UBW32 MX460

Title: UBW32_MX460_v262	
Version:	
3/31/2010 11:20:56 AM	
Drawn By:	1/1

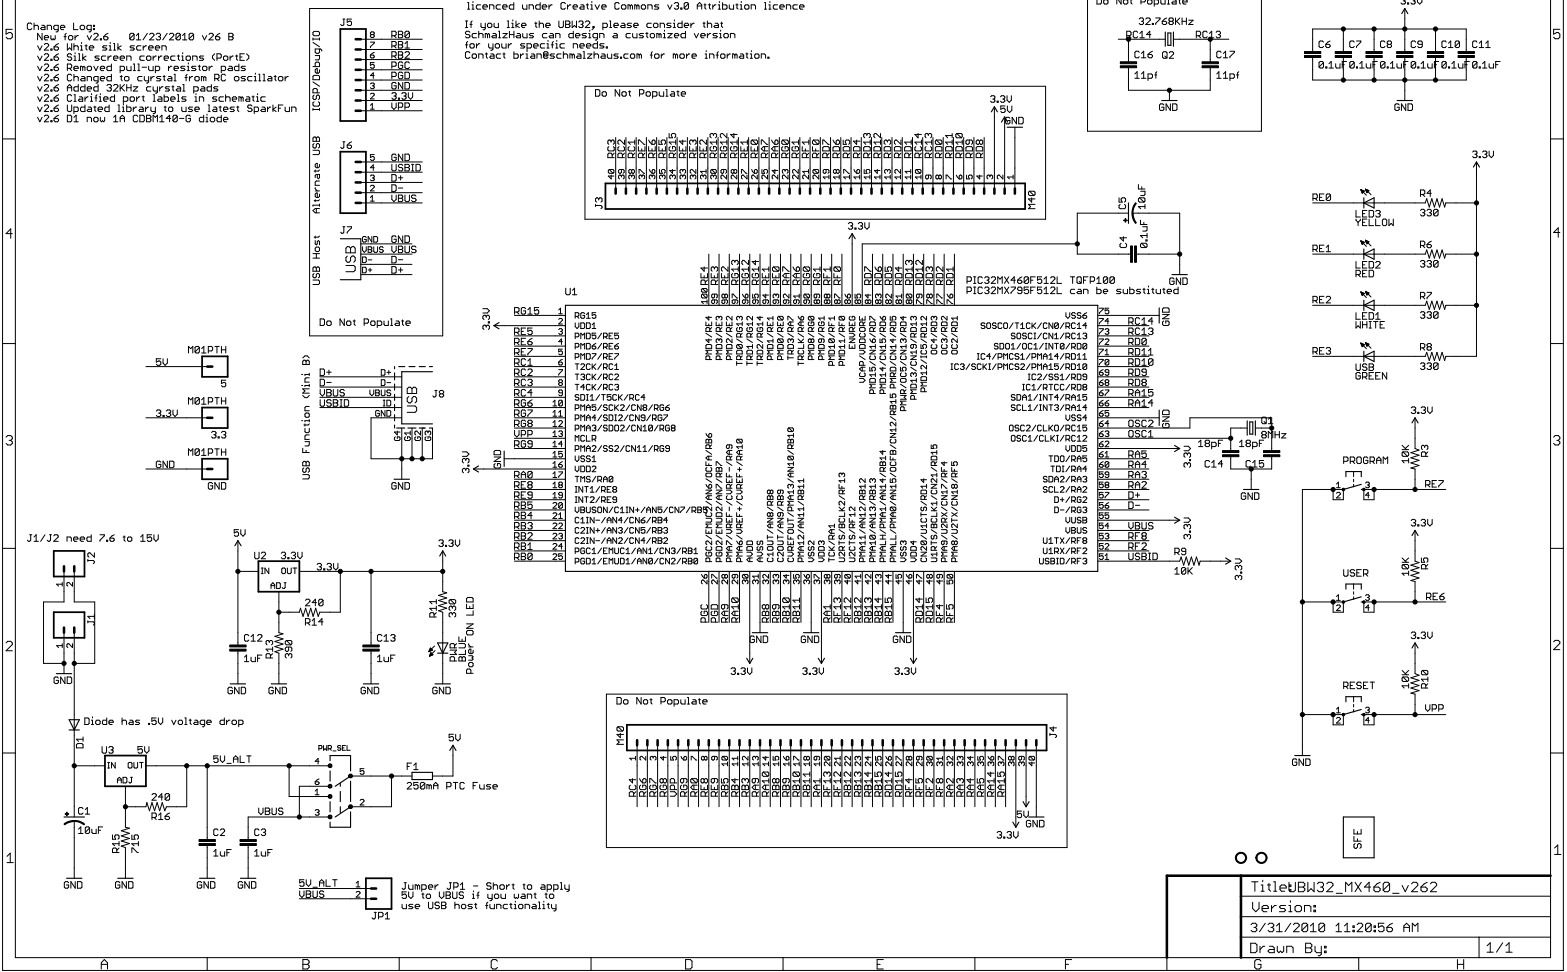
- Change Log:
 v2.6 New for v2.6 01/23/2010 v26 B
 v2.6 Update silk screen
 v2.6 Silk screen corrections (PortE)
 v2.6 Removed pull-up resistor pads
 v2.6 Changed to crystal from RC oscillator
 v2.6 Added 32KHz crystal pads
 v2.6 Clarified port labels in schematic
 v2.6 Updated library to use latest SparkFun
 v2.6 D1 now 1A CDBM140-G diode
